December 12, 2019

**Re: Subsurface Conditions Report Addendum - Revised
Point Wells Redevelopment
Unincorporated Snohomish County, Washington
17203-57**

In this letter, we provide additional geotechnical information to address items in Snohomish County's May 9, 2018 Supplemental Staff Recommendation document, the County's May 9, 2018 landslide hazard area memorandum (from Randolph Sleight), and the County's June 1, 2018 Findings of Fact/Conclusions of Law document for the hearing examiner. We clarify project geotechnical information provided in the Subsurface Conditions Report (Hart Crowser 2018) and provide supplemental geotechnical information for the Point Wells Redevelopment (Project) in unincorporated Snohomish County, Washington. This letter is an addendum to our April 20, 2018 Subsurface Conditions geotechnical report. Subsequent sections are organized using the general headings from the County's May 9, 2018 Staff Recommendation document.

Section G-G'
Wall and Backfill, Pseudostatic

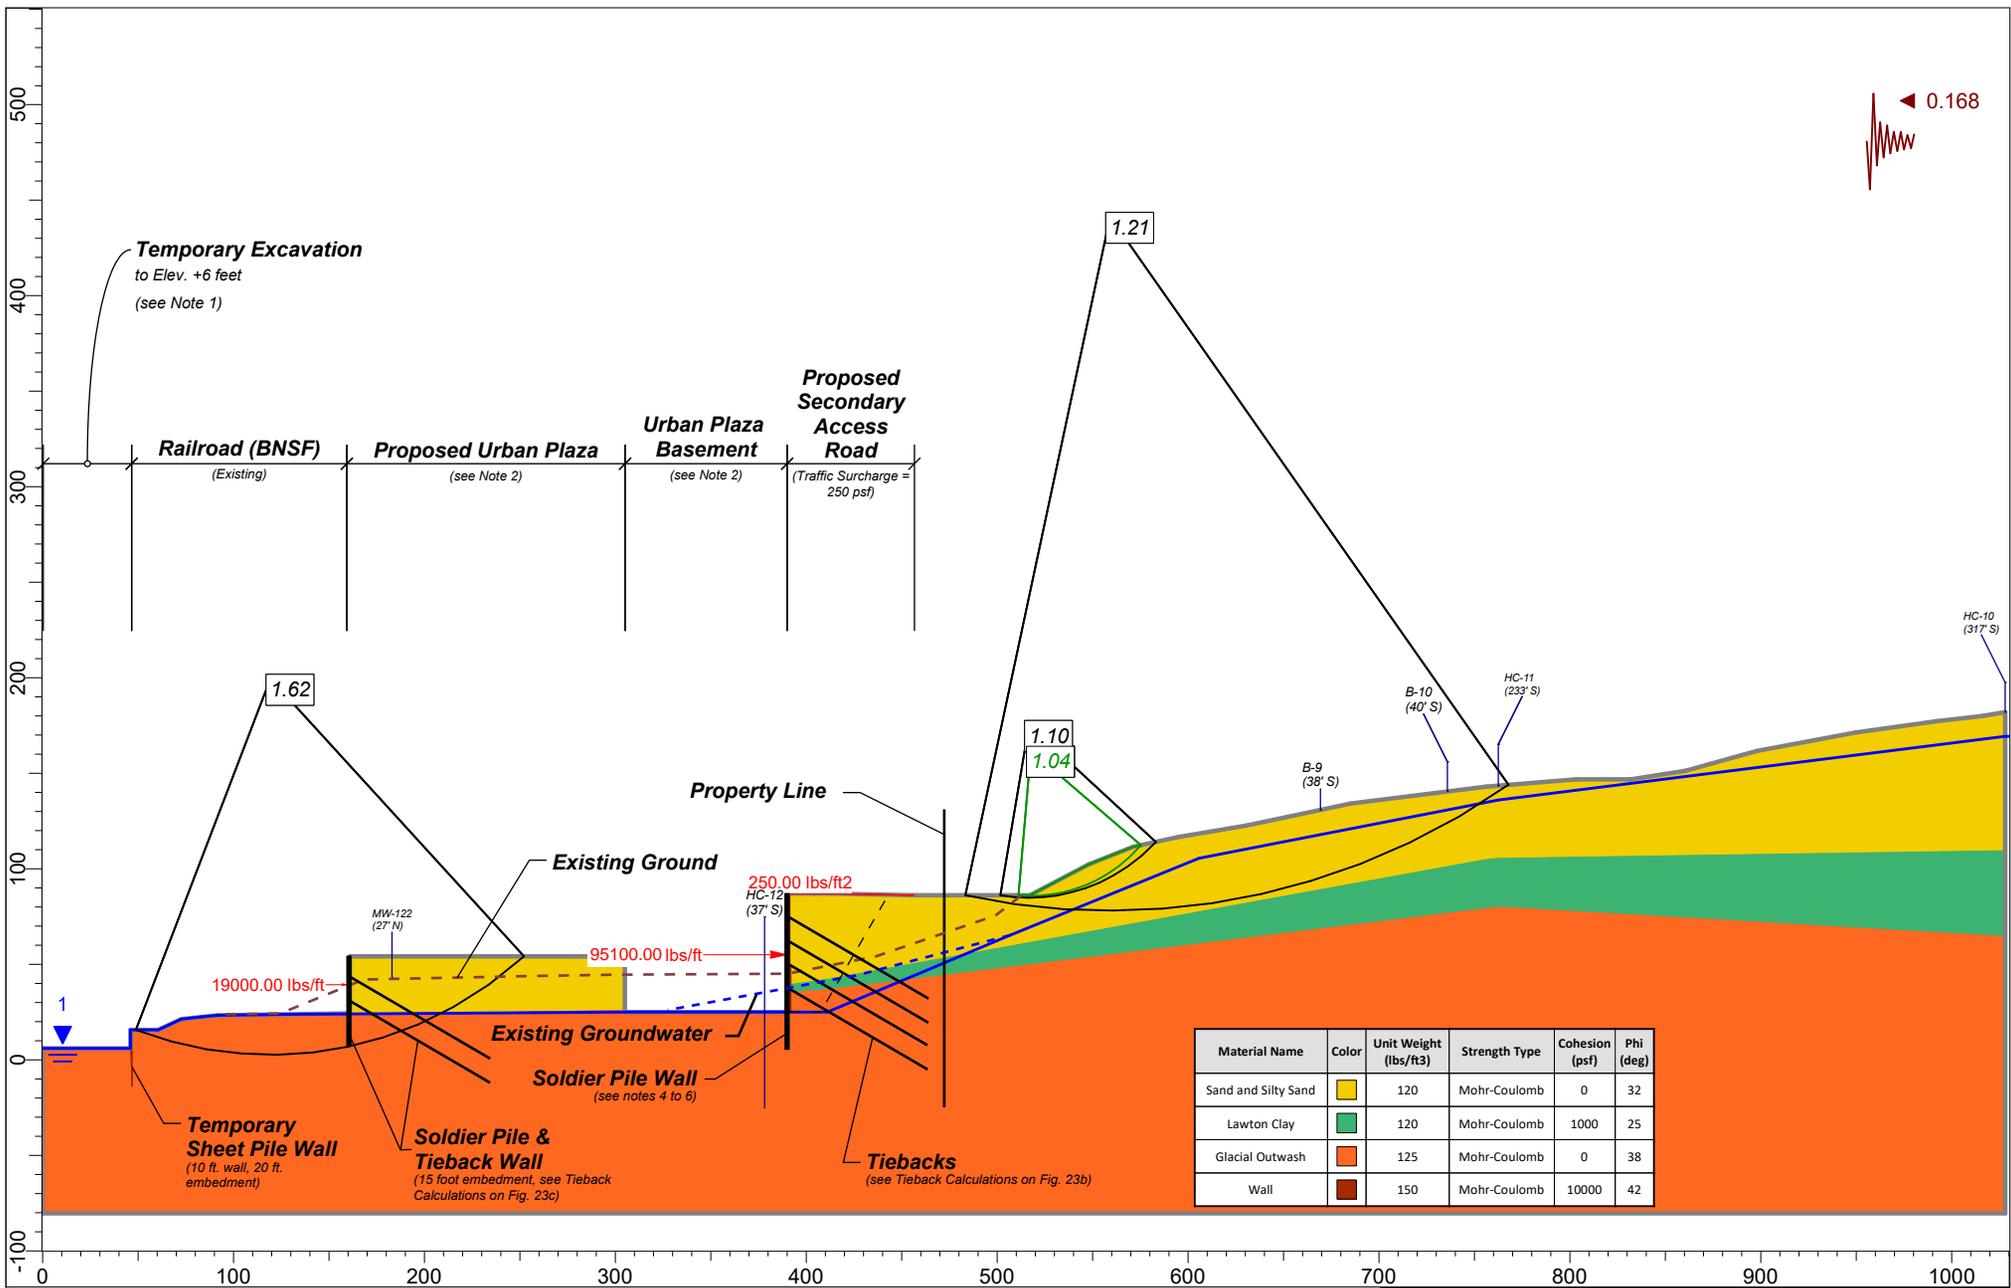
Road. The horizontal force is not directly providing a stabilizing force to the overall critical slip surface in the slope (Figure 23 and 23a, FS = 1.109 and 1.04 to 1.21). Instead, as discussed in Section 5.1.6.1 of our geotechnical report (Hart Crowser, 2018), the stabilized/retained section of the Secondary Access Road acts as a buttress for the east slope to improve the overall stability over existing conditions. This result is demonstrated in our geotechnical report by the FS increasing from the existing conditions (Figures 18a and 19a, below code minimum FS, Table 3a) to the retaining wall with backfill option (Figures 22a, 23a, and 23d, near or above code minimum FS). This is also demonstrated in Table 3a. Note the following specifics about the stability analysis.

- Figures 22a and 23a include excavation west of the railroad to an elevation of +6 feet, showing FS above the code-required values. This excavation would be temporary for either removal of contaminated soil or construction of building basements and would likely include sheetpile shoring. Final grades just west of the railroad will be raised to about an elevation of 50 feet, which will act as a resisting force to potential global instability extending from the east slopes under the railroad, which is unlikely. These figures only show the two minimum/critical slip surfaces above the proposed retaining wall and west of the railroad. However, the analysis included larger surfaces starting above the retaining wall and extending under both the retaining wall and the railroad; but, the safety factors were well above the code-required values.

**Section G-G' East Retaining Wall
Force Calculation, Pseudostatic**

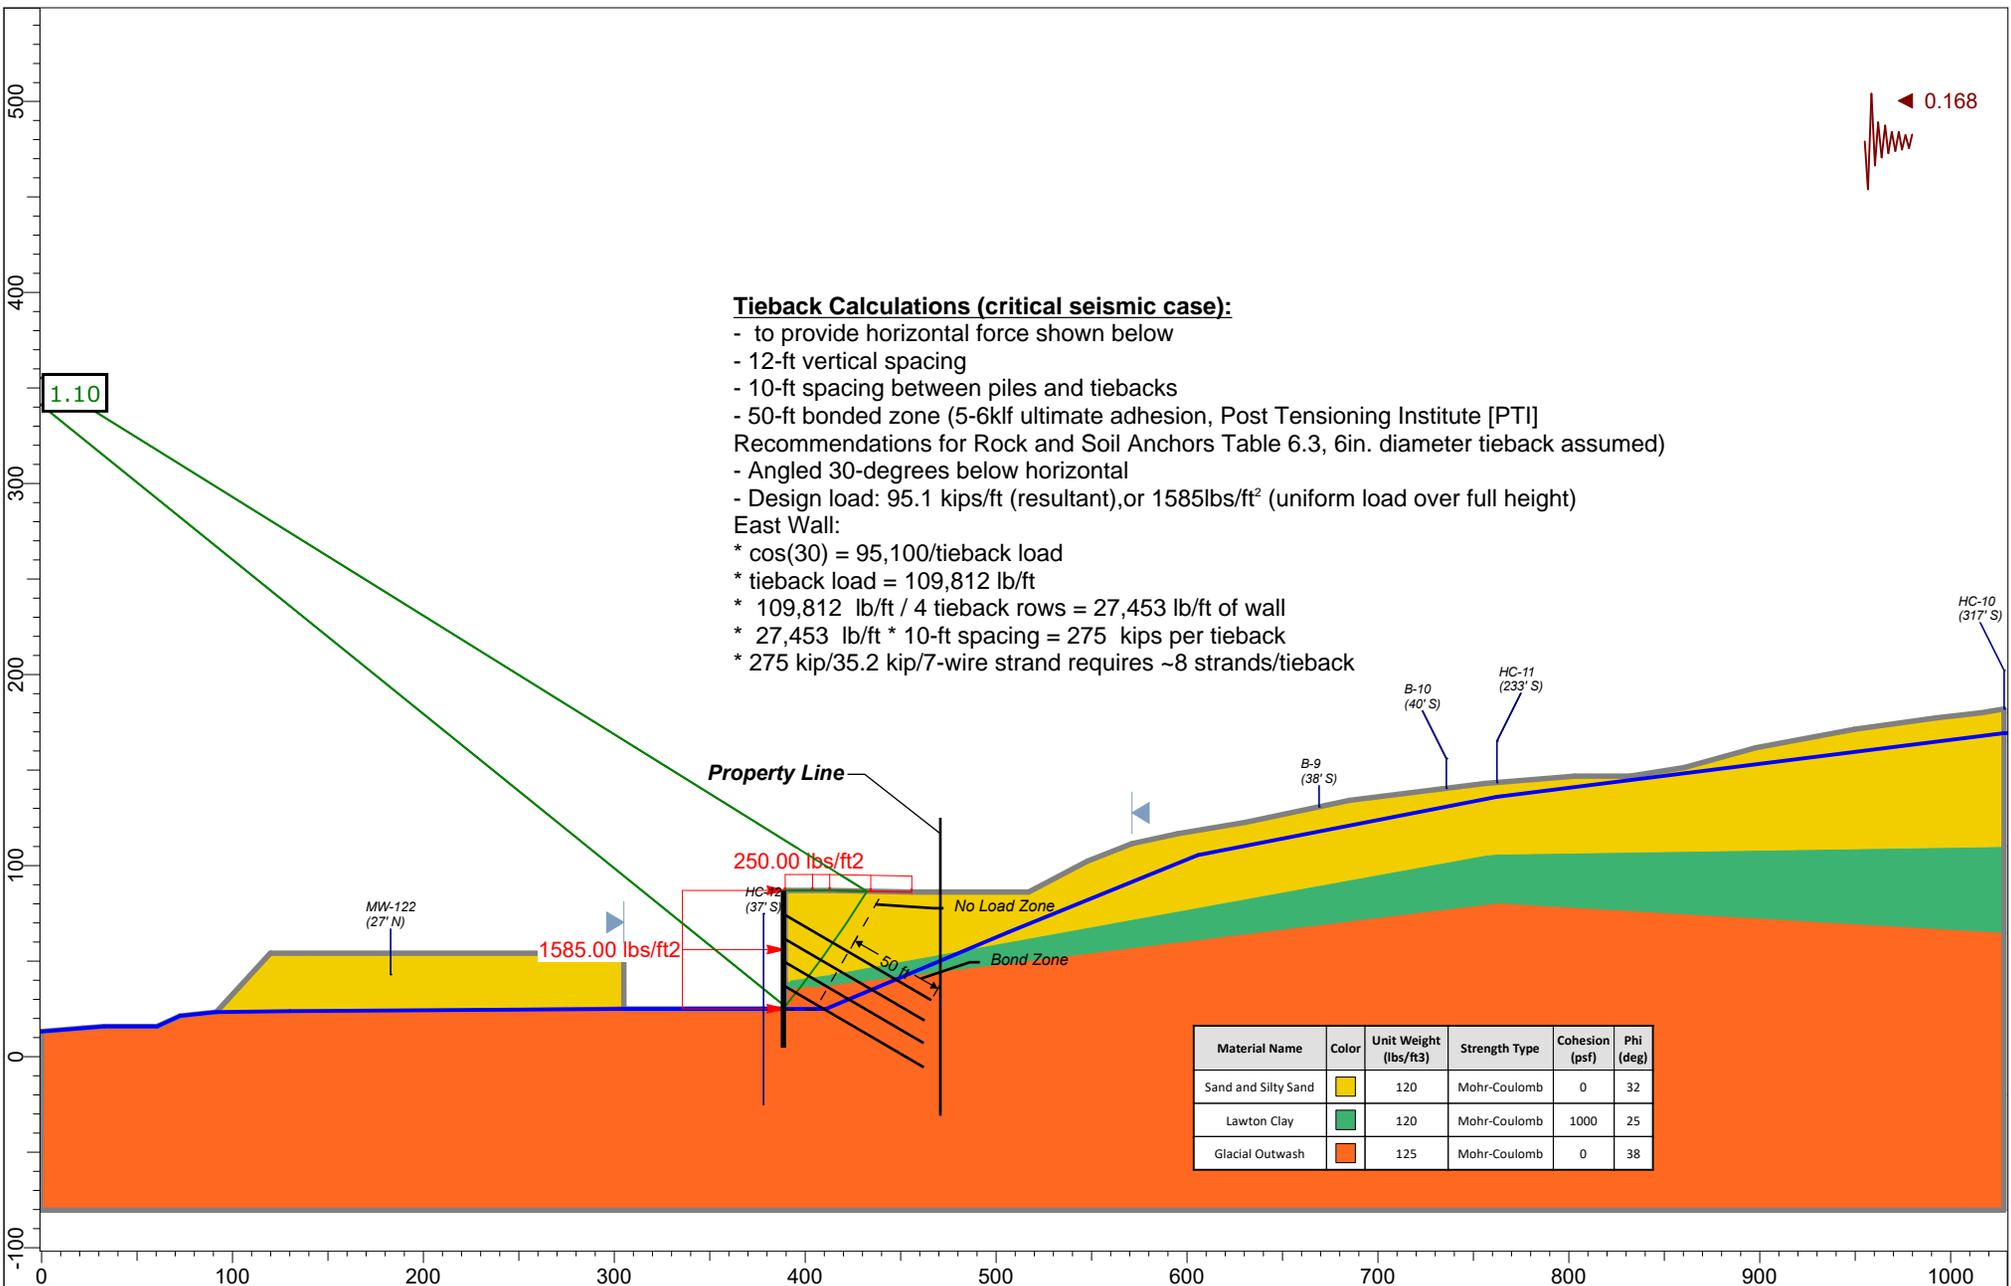
- Geotechnical slope stability analysis/calculation results on Figures 22a, 22b, 23a through 23d show how a generic retaining wall providing a resisting force of 77 kips (kip = 1,000 pounds) per foot of wall length increases FS to the County code-required values. Several retaining wall options could be used. The critical seismic case on Figures 23b and 23c demonstrate with calculations how a permanent soldier pile and tieback retaining wall system is feasible to provide these resisting forces (including soldier pile and tieback geometry and loads). Note the following specifics about the stability analysis.

- The permanent retaining wall resisting force of 95.1 kips per foot of wall is lower than loads used on other of our slope stabilization projects (170 to 190 kips per foot of wall). Thus, if during final design, some additional load resistance is required, additional capacity can be provided, which also supports the feasibility of the proposed slope stabilization method.

**Section G-G' Wall and Backfill
Buttress Option, Pseudostatic**

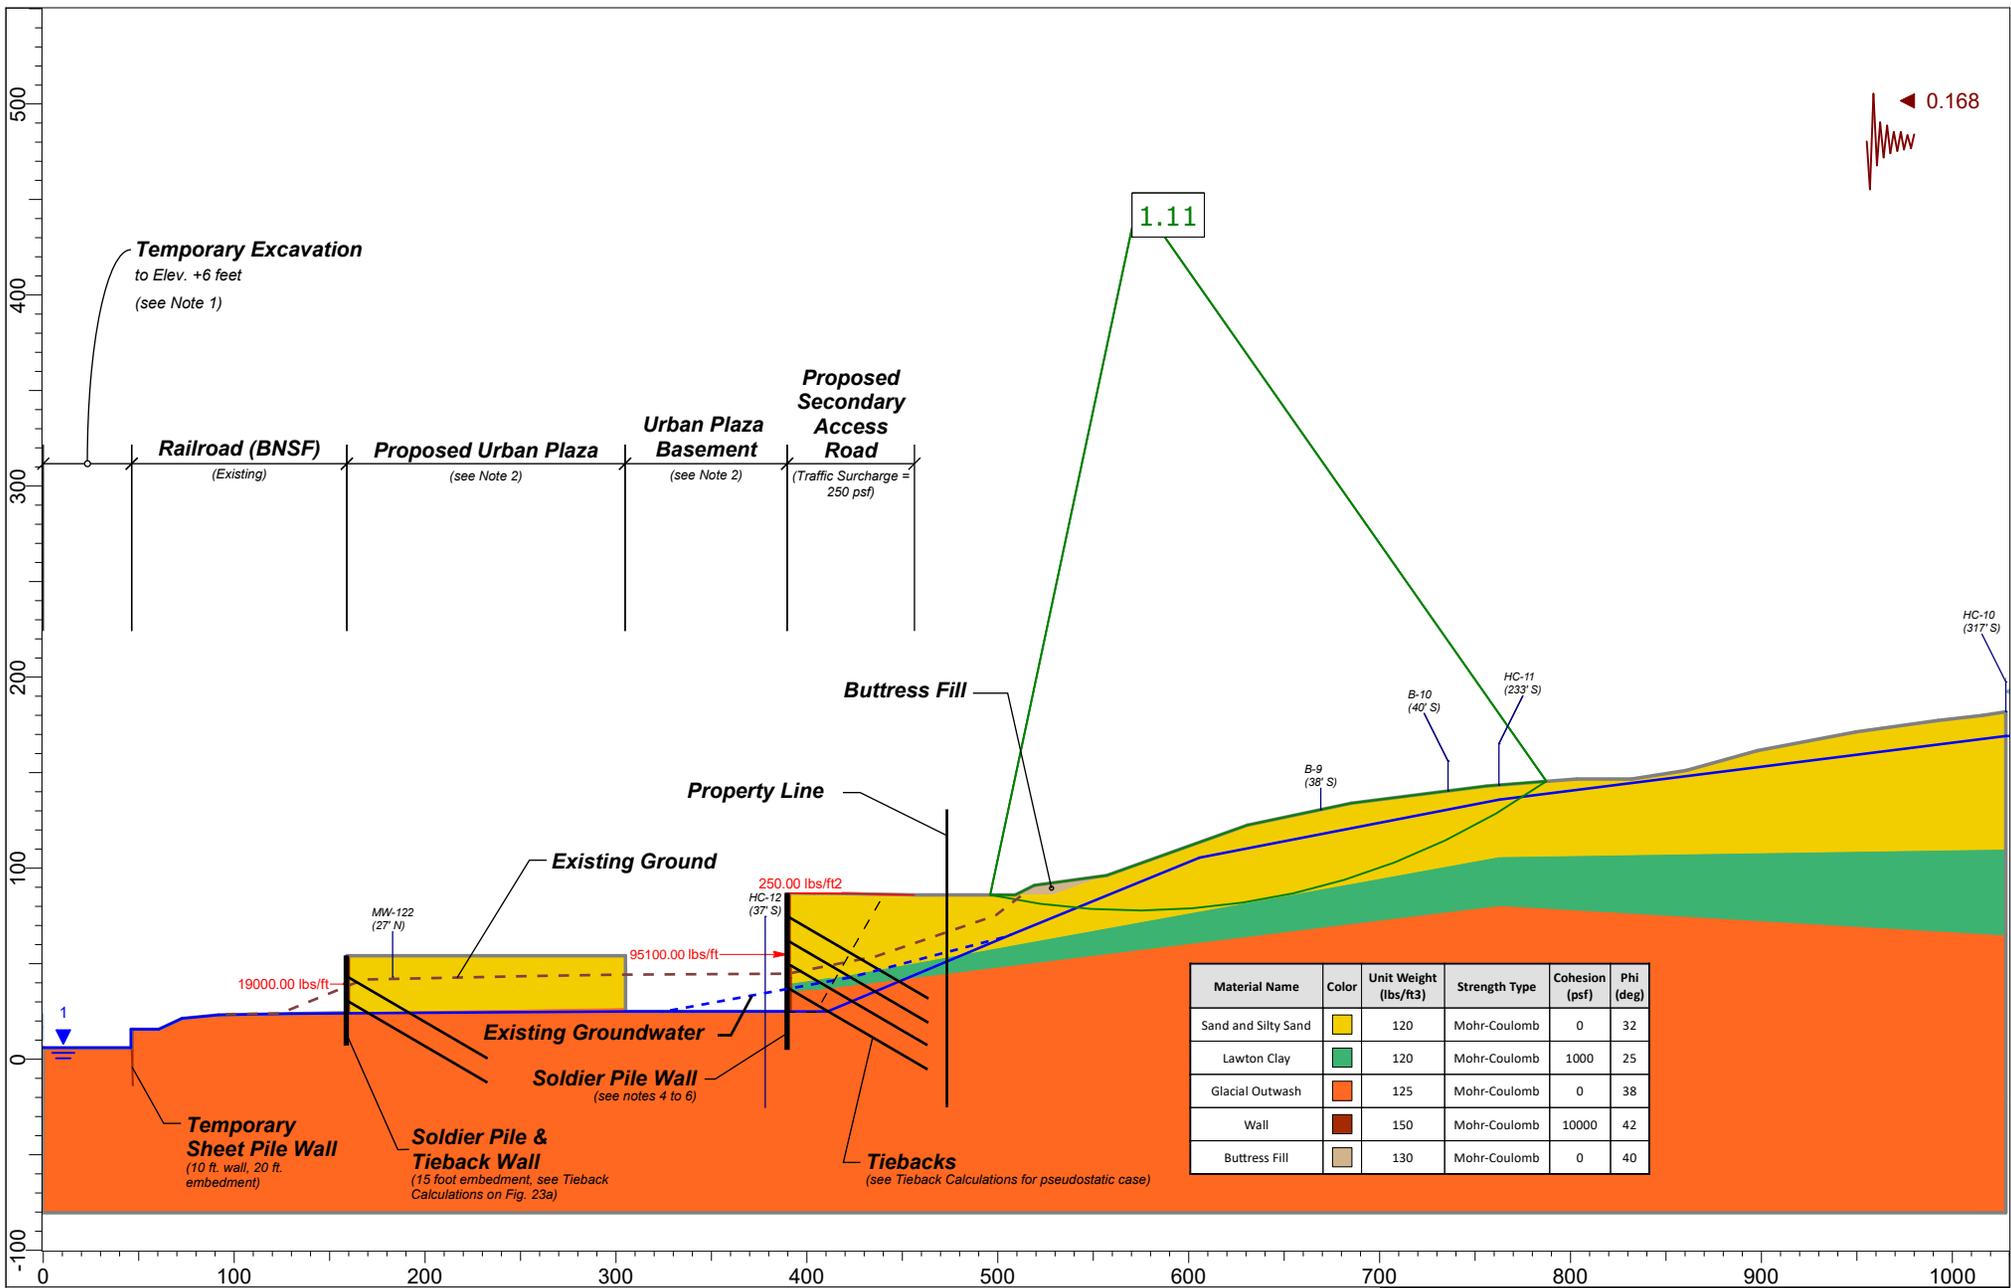
- Figure 23d shows one feasible slope remedy by simply adding a small soil buttress/berm at the base of the East slope to increase the FS from 1.04 to greater than the code-required seismic FS of 1.10.
